**RE: 13704 Ellena Gallegos NE
Grading Plan
Stamp Date: 8/8/17
Hydrology File: E24D002A**

13704 ELENA GALLEGOS	DRAWN BY WCVJ
	GRADING AND DRAINAGE PLAN	DATE 7-16-17
7/18/17 8/8/17		21740-LAYOUT-5-28-17
DAVID SOULE P.E. #14522		SHEET #
		JOB # 21740

**RE: 13704 Ellena Gallegos NE
Grading Plan
Stamp Date: 7/18/17
Hydrology File: E24D002A**

SITE HYDROLOGY

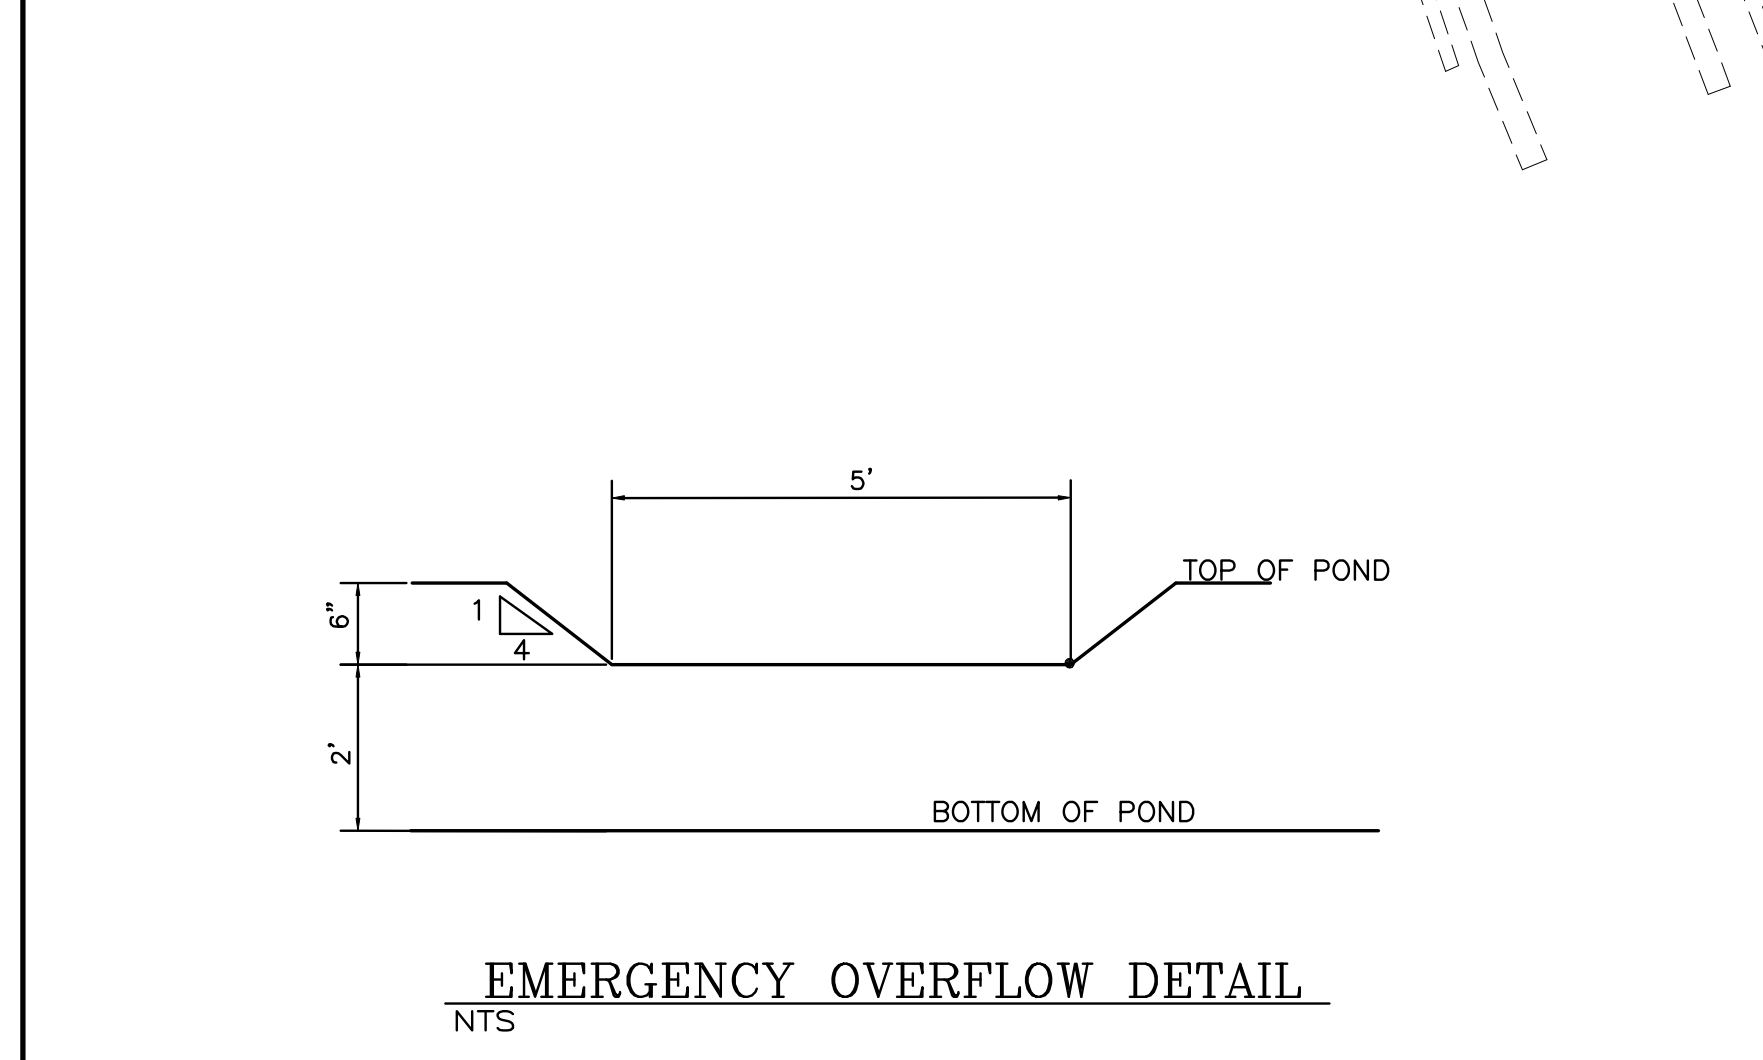
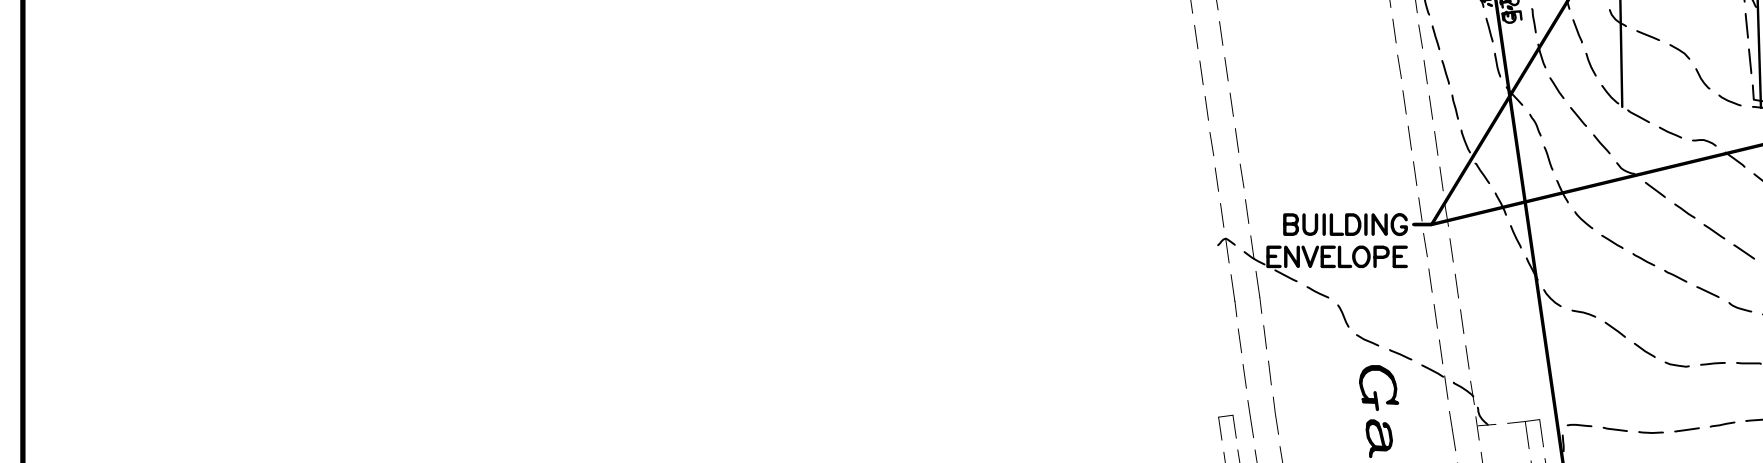
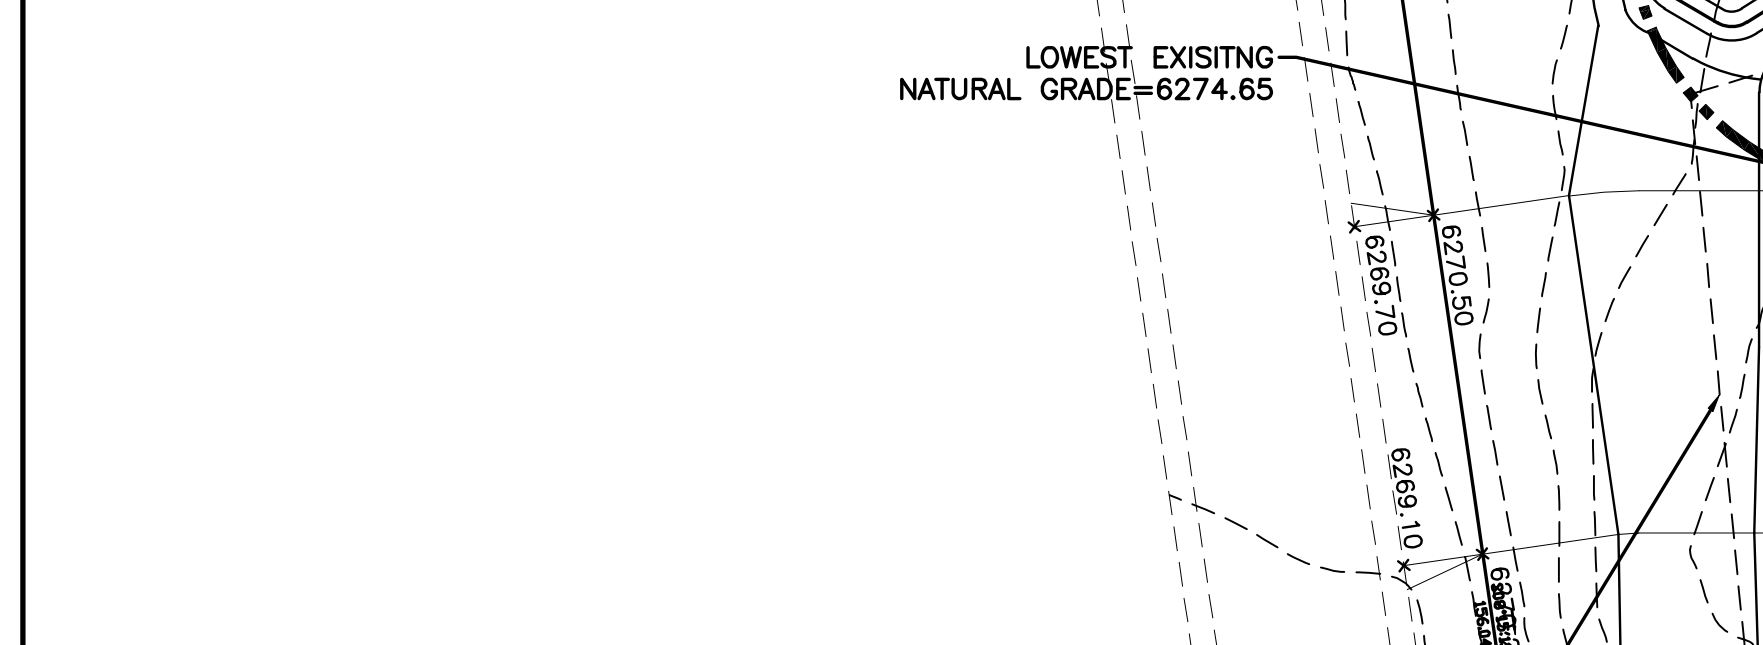
1. Please provide both the beginning and ending flowlines for all the cobble swales.
WE HAVE ADDED THE INVERT ELEVATIONS
2. Please add the weir calculations for the emergency overflows.
WE HAVE ADDED TO THE CAACLULATIONS
3. There is enough room on the sheet, so please enlarge the Site Hydrology calculations and notes. **WE ENLARGED**

OVERFLOW CAPACITY
Weir Equation:
 $Q = C L H^{3/2}$
Where for 100-year, 6-hour storm
Ea= 0.8
Eb= 1.38
Ec= 1.46
Ed= 2.64
Qa= 2.2
Qb= 2.92
Qc= 3.73
Qd= 5.25
H= 0.5 ft
L= 5 ft
Q= 5.1 cfs
Q= 1.52 cfs
C= 2.95
Q= 2.95X 5.0 X(5/1.5)
